A R K A N S A S Department of Environmental Quality

NPDES Permit No AR0035602, AFIN 56-00047

Proposed Consent Administrative Order

CONSENT ADMINISTRATIVE ORDER

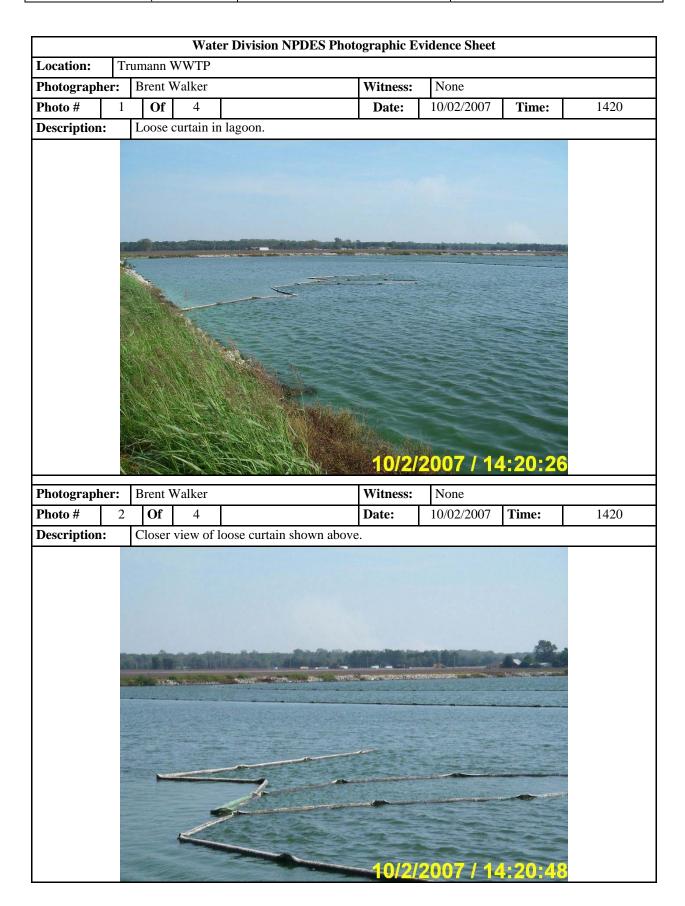
- a. Multiple curtains in the two lagoons were loose or detached and were in need of repair/maintenance/replacement. **REPEAT VIOLATION**
 - b. There was no laboratory QA/QC program in place. **REPEAT VIOLATION**
